**BIDDING AND CONTRACT DOCUMENTS  
FOR THE  
METROPOLITAN SEWERAGE DISTRICT OF BUNCOMBE COUNTY  
WEAVERVILLE PUMP STATION AND FORCEMAIN SYSTEM IMPROVEMENTS**

**ADDENDUM NO. 3**

**Date Issued: December 13 2023**

## SECTION 009113 – ADDENDUM #3

GODWIN DRI-PRIME® CD160M  
ONE (1) PUMP | SYSTEM CURVE

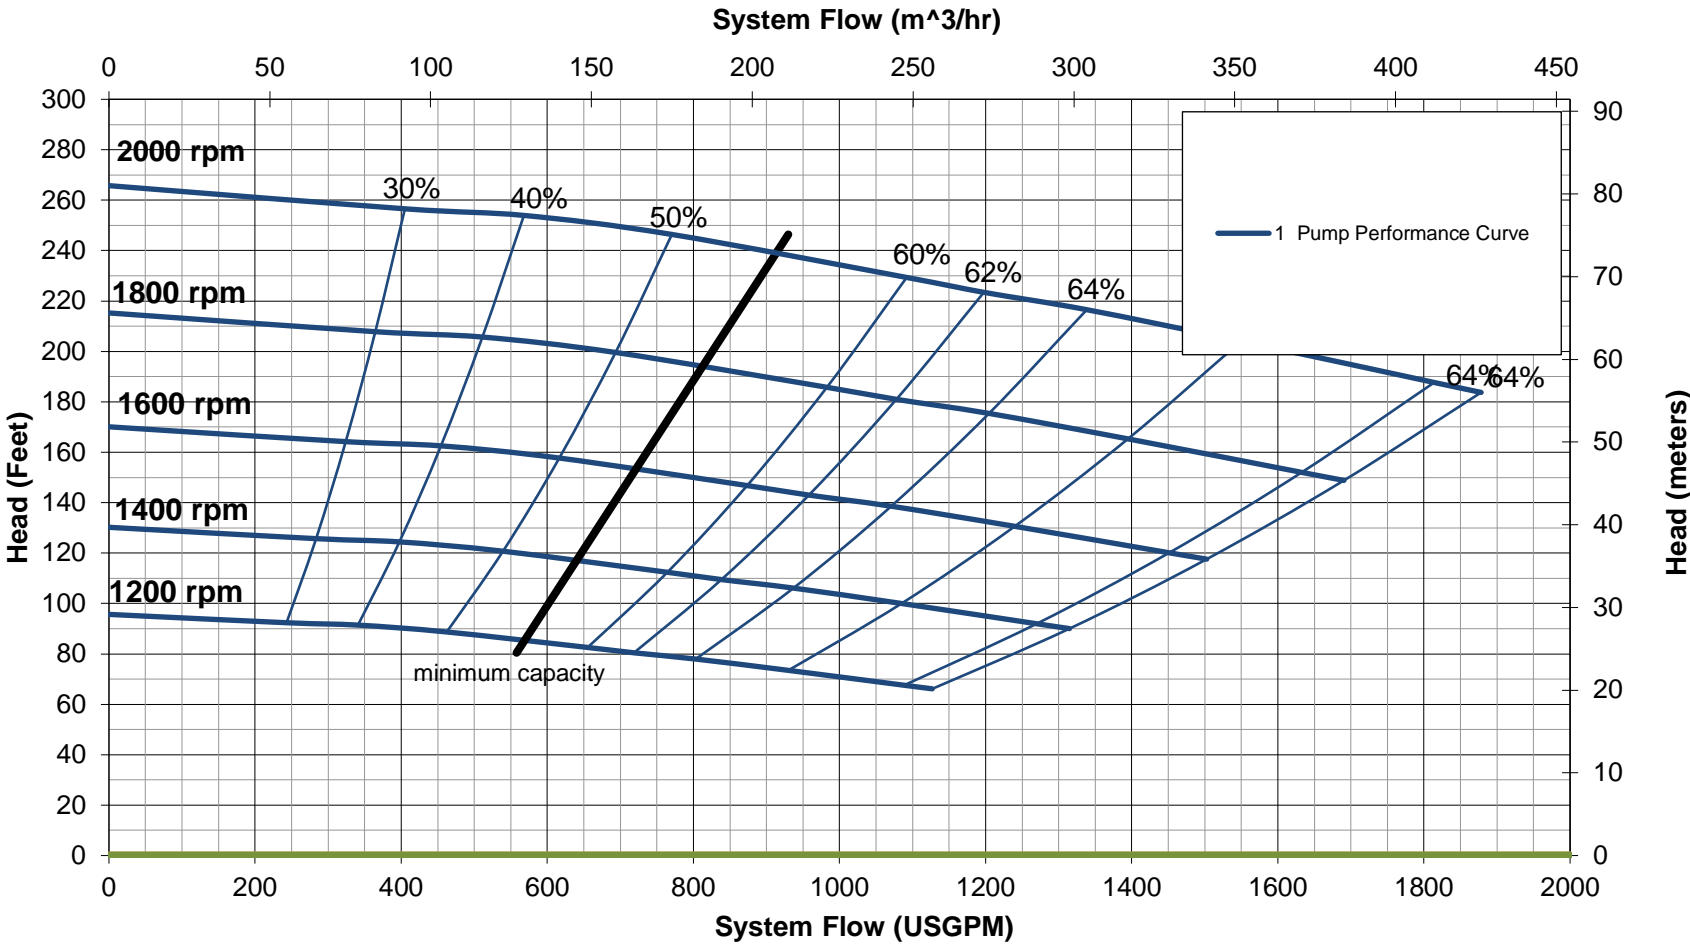
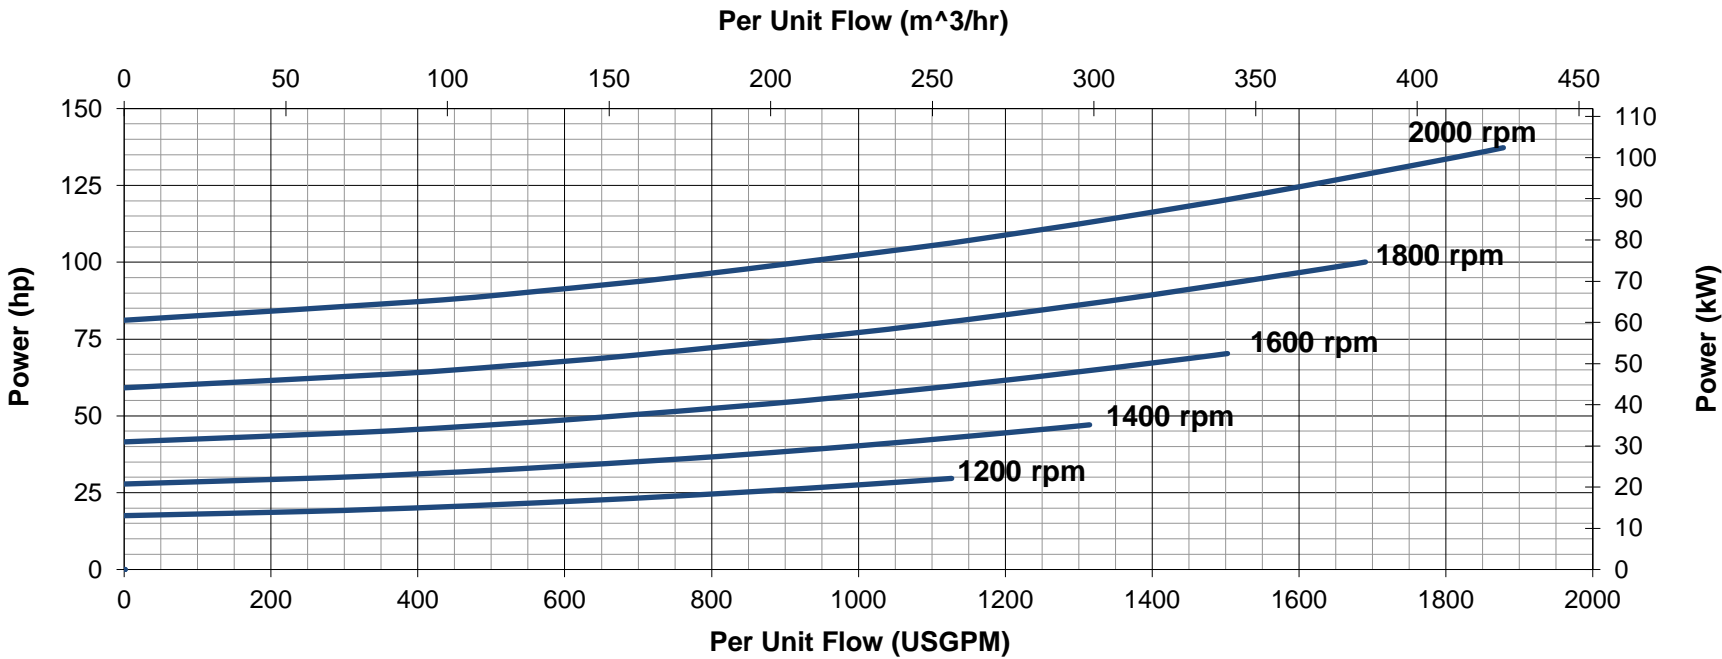
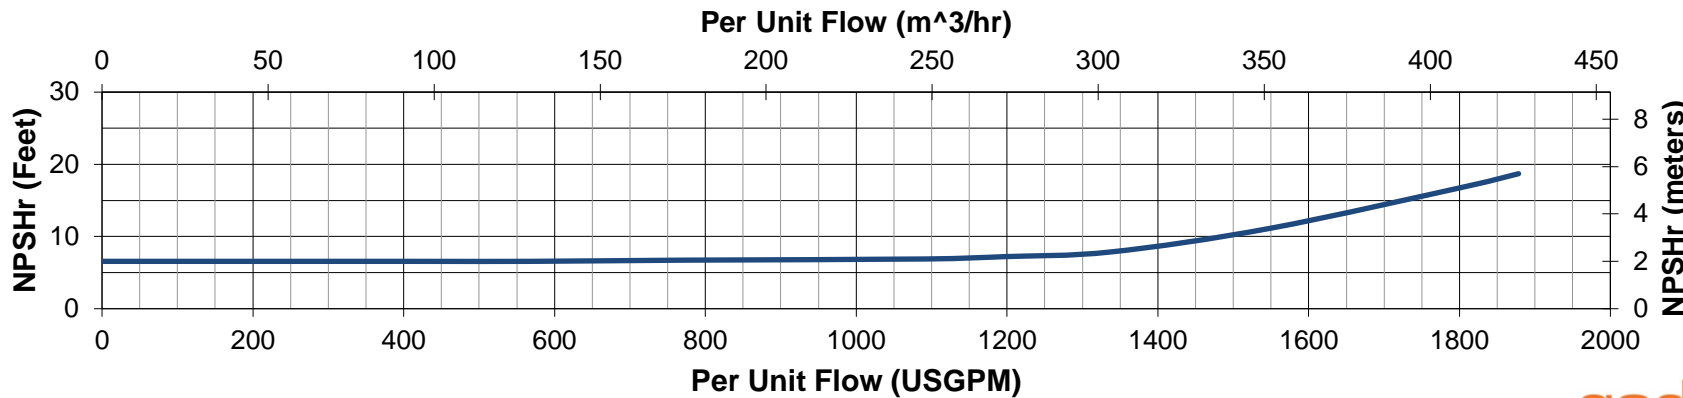
25. **QUESTION:** Is the Bypass pump S08-P-05 part of this contract if so, what is the spec for this pump?

**RESPONSE:** No, the bypass pump is not being procured as part of this contract. This is an existing pump that will be reconnected as part of this contract. Refer to drawings. See attached pump curve and data sheet.
